DRB CASE ACTION LOG - BLUE SHEET

Project #: 1007488 Application #: 12DRB-7072
Project Name: Sisters of the Order of St. Dominic
Agent: DKKER Pouch Sabatini Phone #:

**Project #1007488 12DRB-70172 Amended Site Development Plan for Building Permit –
Lot(s) D-1E-1, Sisters of the Order of St. Dominic zoned SU-2/IP-EP**

Re: DRB Re-submittal to address comments from 6/20/2012 hearing
Request for Amended Site Development Plan for Building Permit
Project # 1007488; 12DRB-70172

A1b
 OF

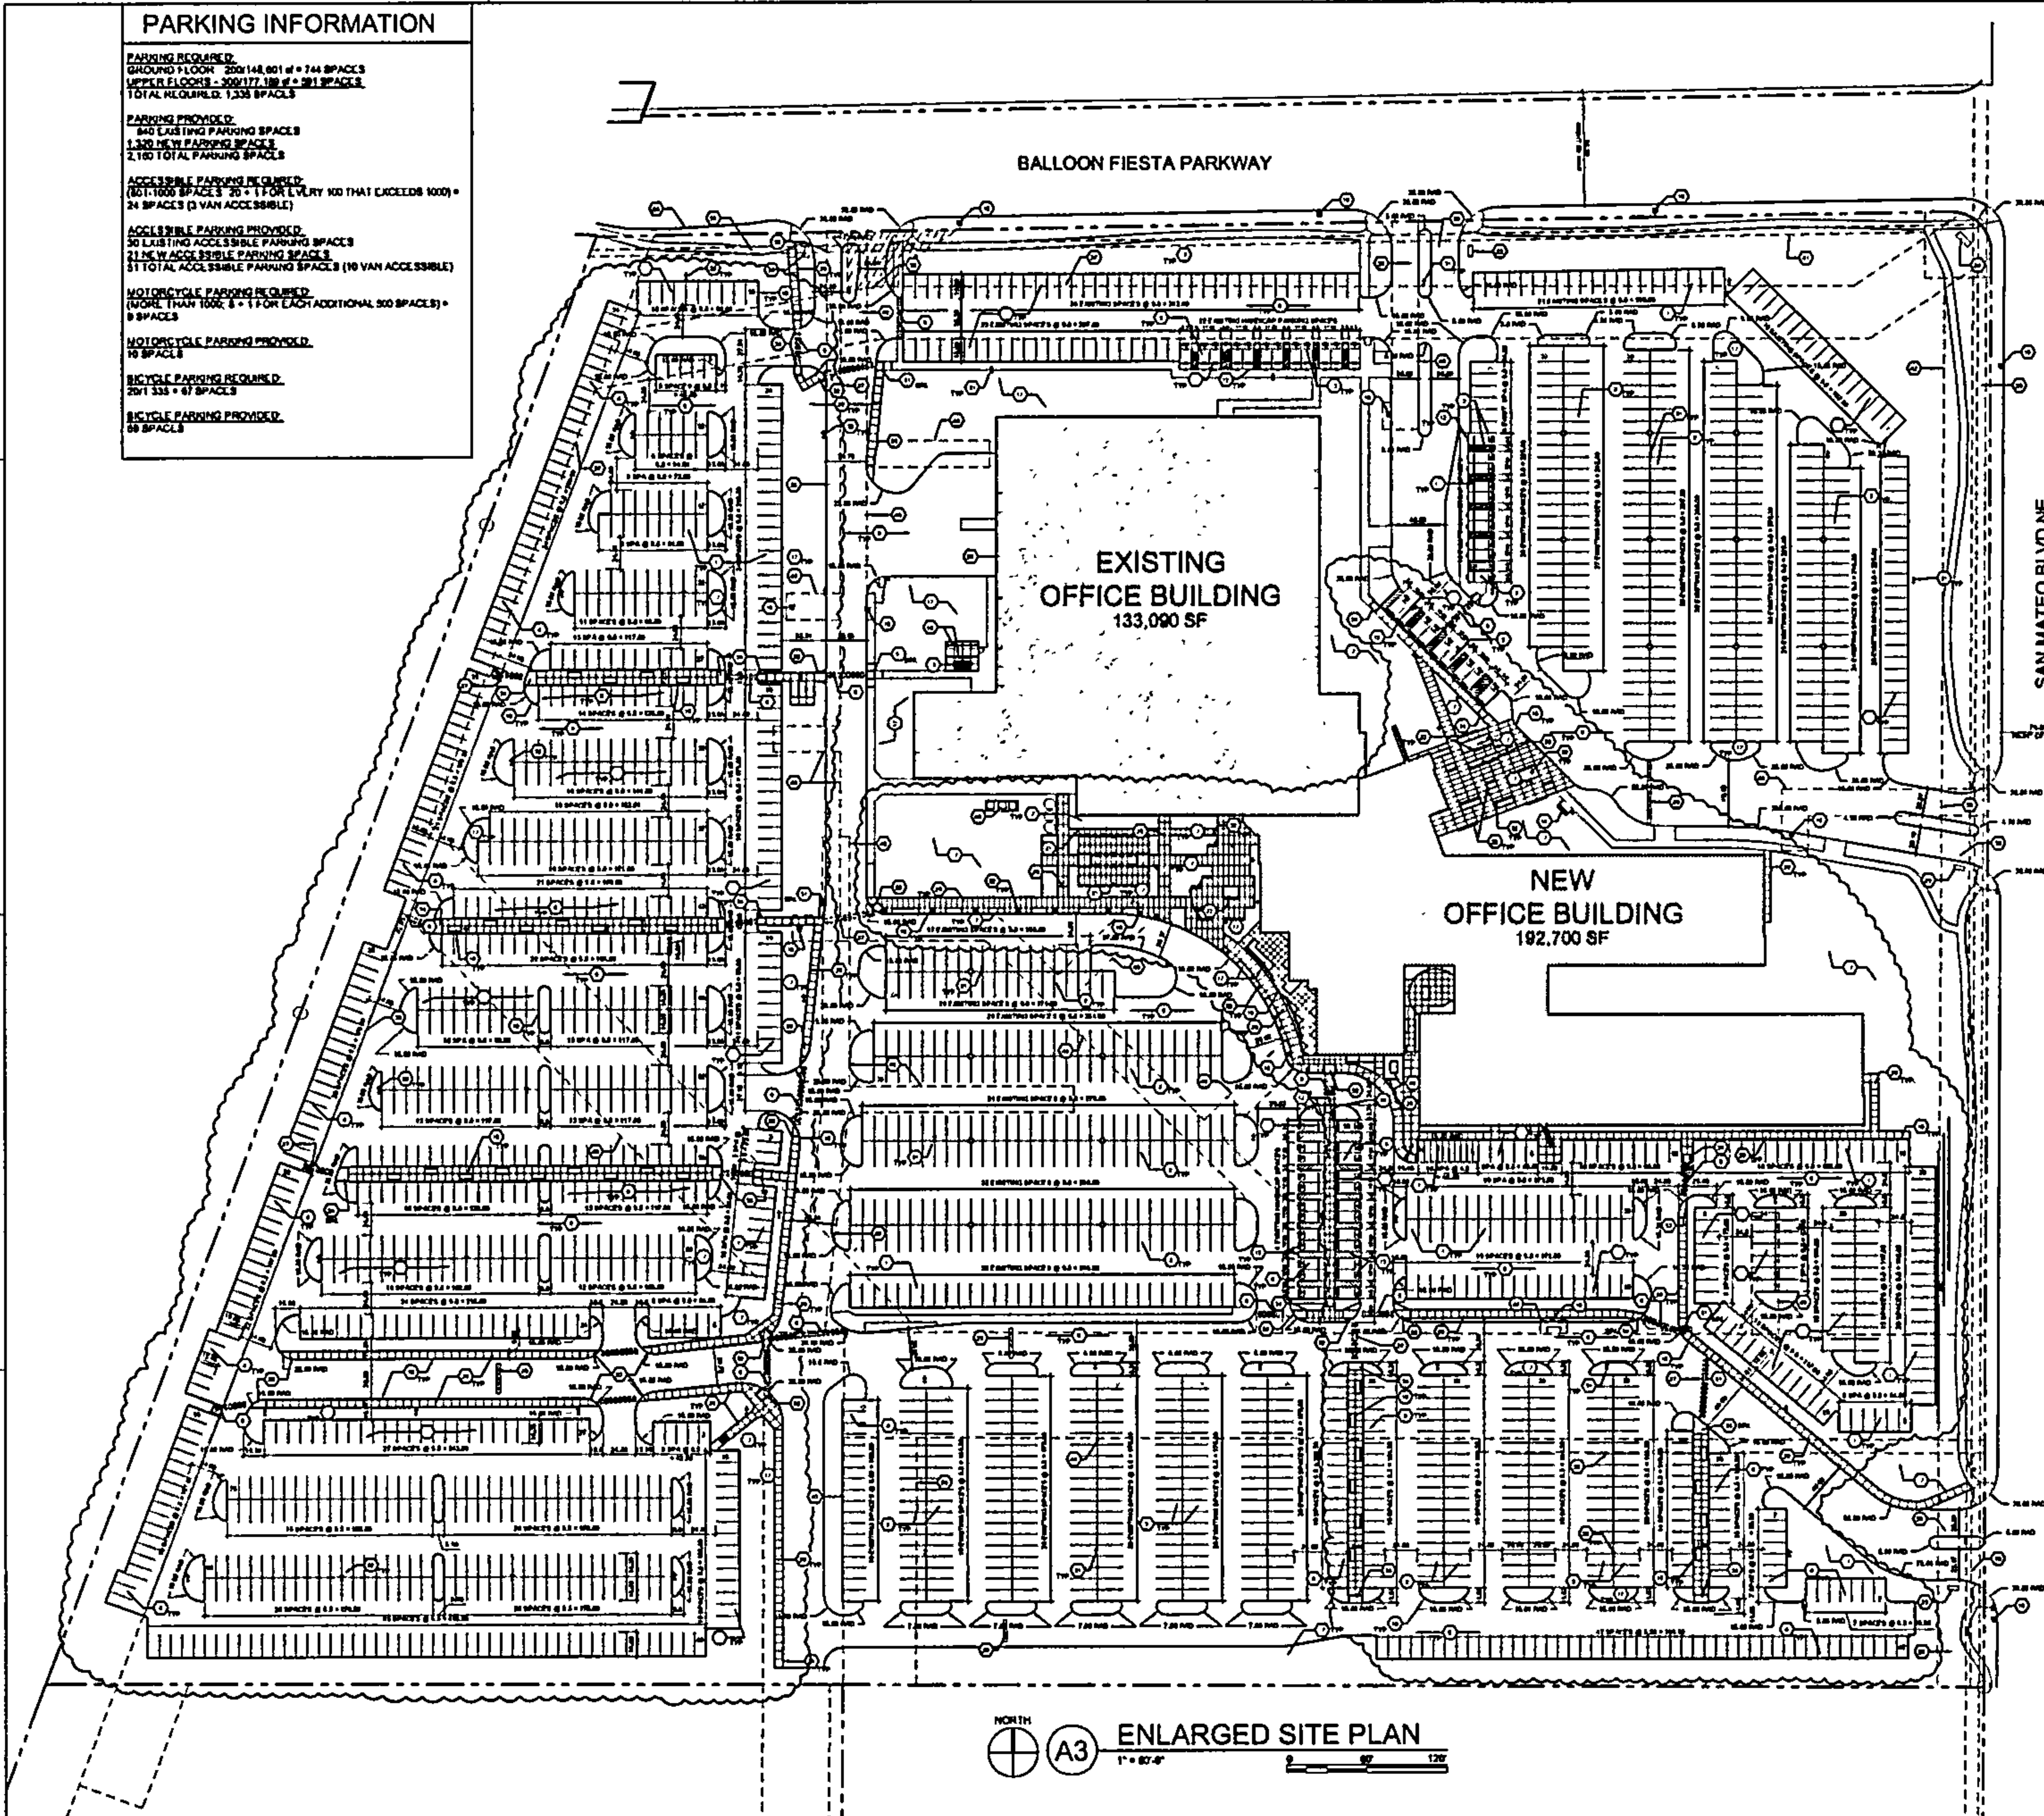
Sheet A1b should be switched with A1a as the cover sheet with signature block. The site plan needs to be clear as to which zone category this development is proceeding under.

- a. Jack Cloud, DRB chairman, provided written comments for Planning. Below are our responses and actions.
- b. First Comment: The first two sheets of the drawing set have been switched so the official Site Development Plan with signature block comes first.

SHEET NO.
C-104
 OF

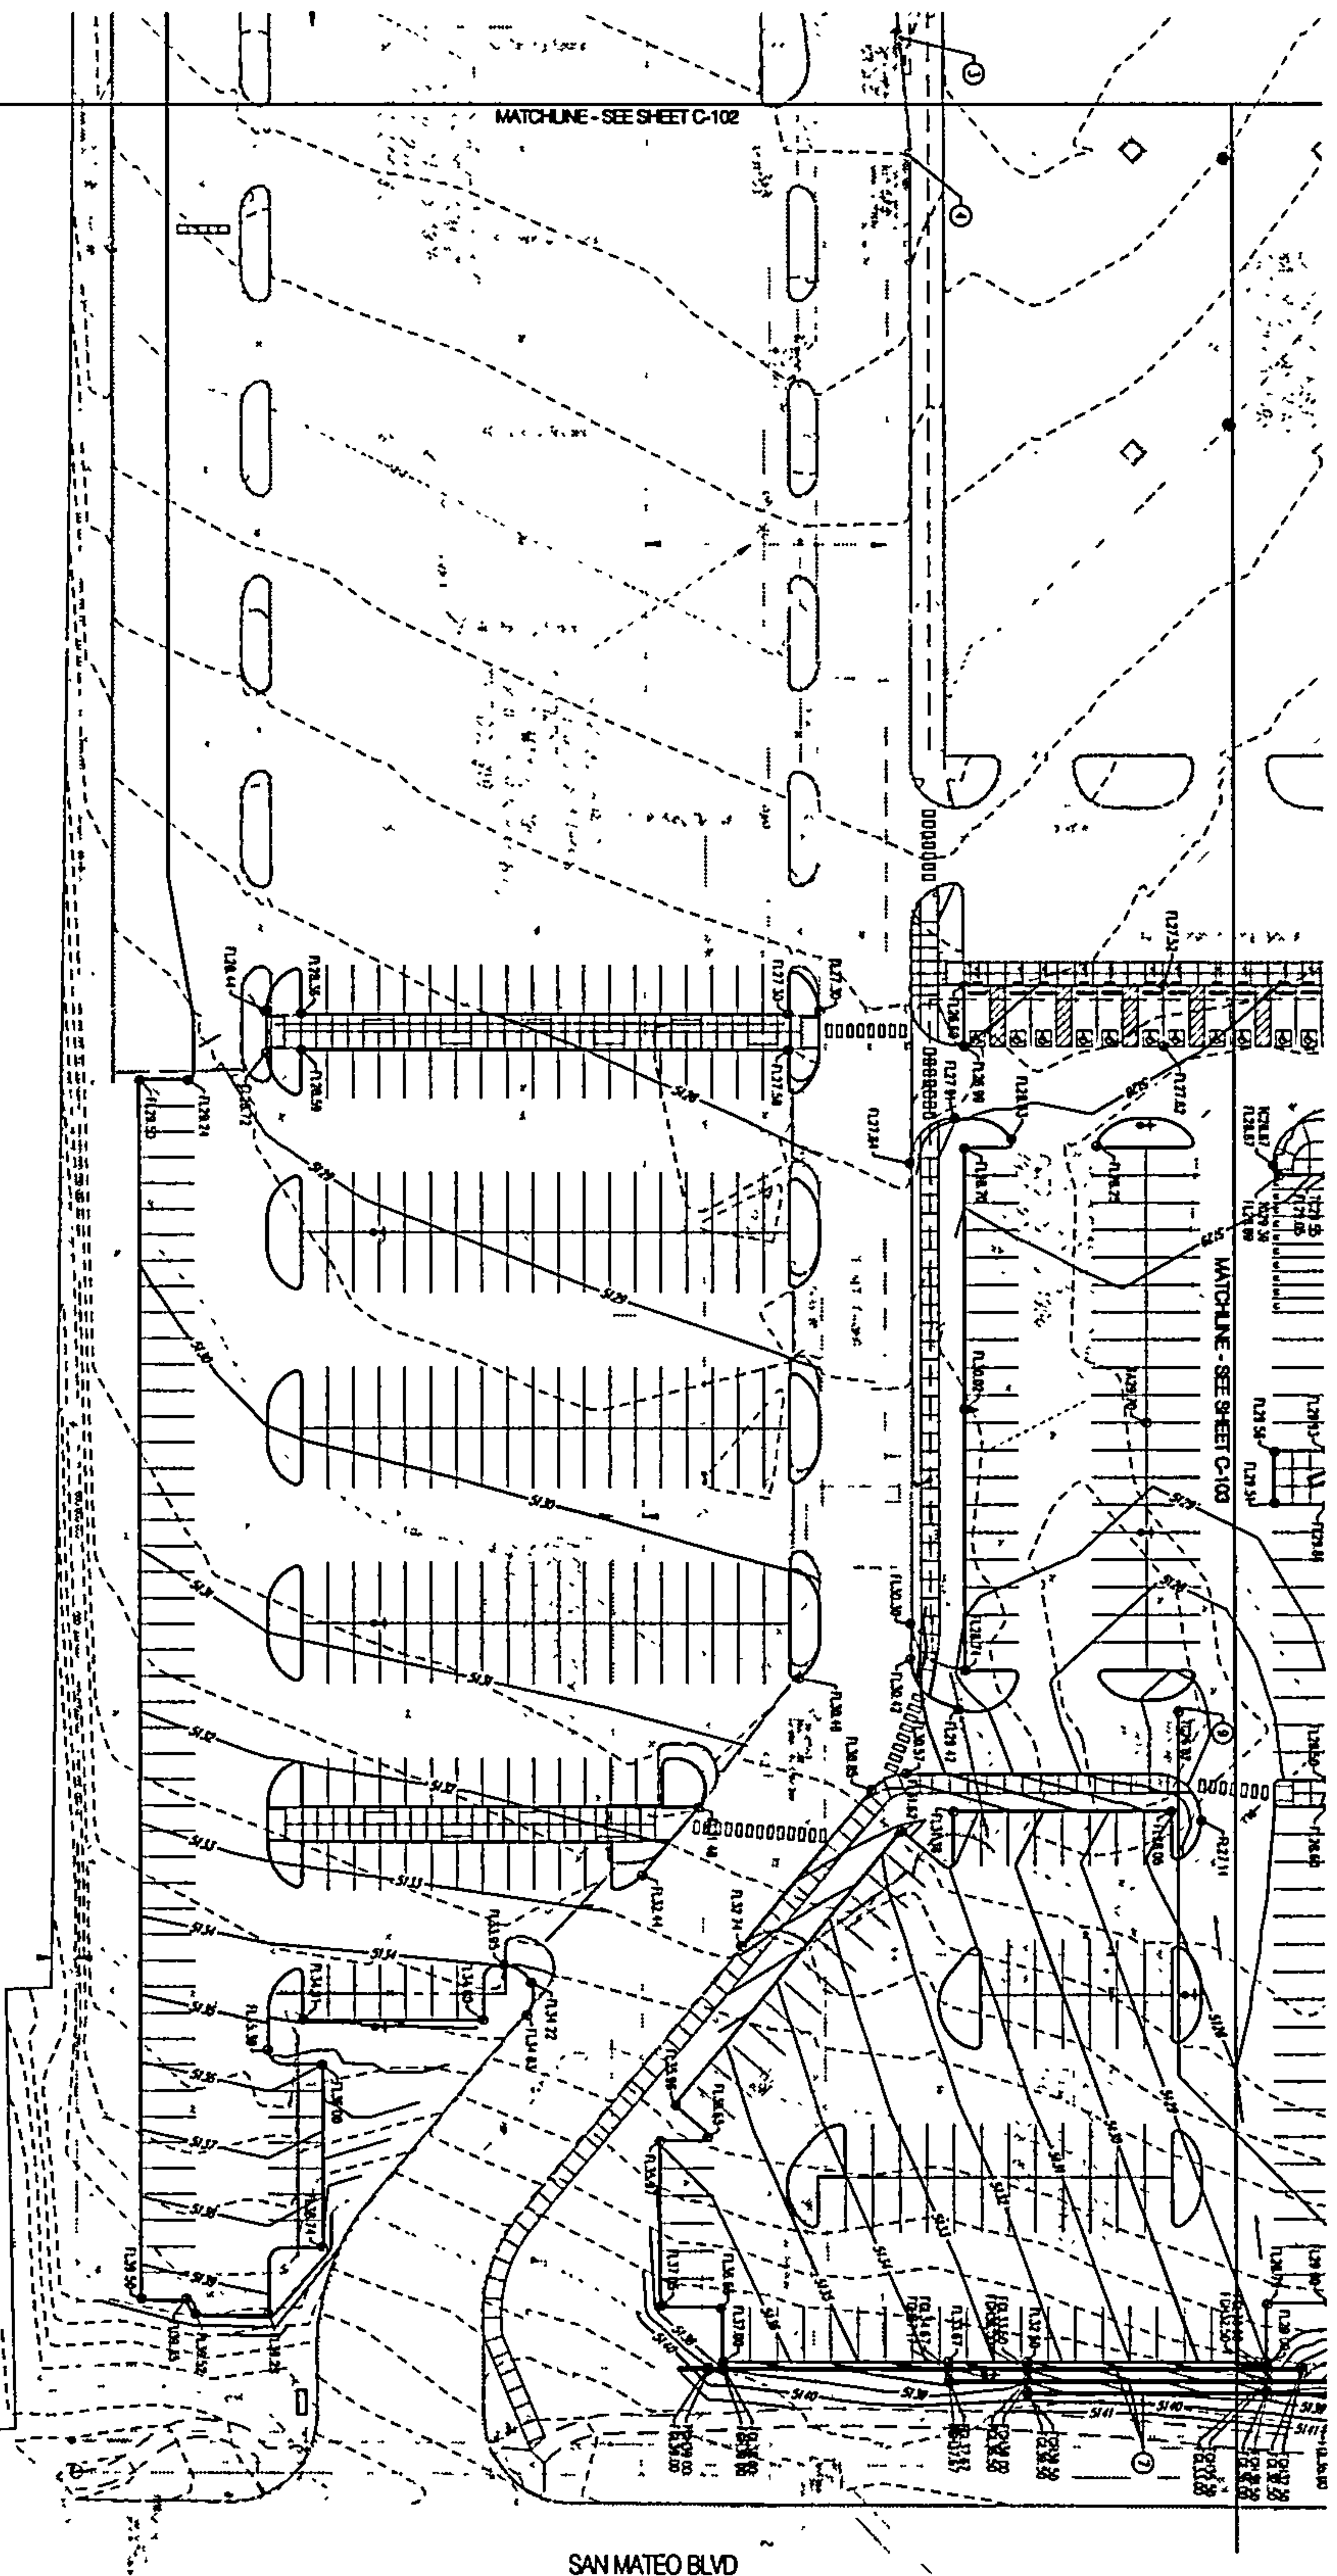
- Since the Grading and Drainage Plan is included in the Site Plan submittal to DRB, include the items listed under Drainage Management Plan.
- Show the proposed curb and gutter and drainage rundown with flows.
- Show that the west side of the water harvesting area is higher than top of curb in Detail 1. In case this area spills, it should spill to the east.
- Provide existing grades along the western property line that adequately depicts the slope.
- Comments provided on the grading and drainage plan were conceptual only. Additional comments may be provided when the plan is submitted for Building Permit approval

- i. First bullet: Items listed under the Drainage Management Plan have been added to the Grading and Drainage Plan.
- ii. Second bullet: Curb and gutter and rundowns are shown conceptually on sheet C-101. Final design plans to be approved by DRC.
- iii. Third bullet: A detail has been added to a new sheet, C-300, showing a retaining wall at the west property line with a top elevation higher than the curb to the east.
- iv. Fourth Bullet: Existing grades have been added to slope west of the site on sheets C-100, C-101, and C-102.
- v. Fifth Bullet: Noted.
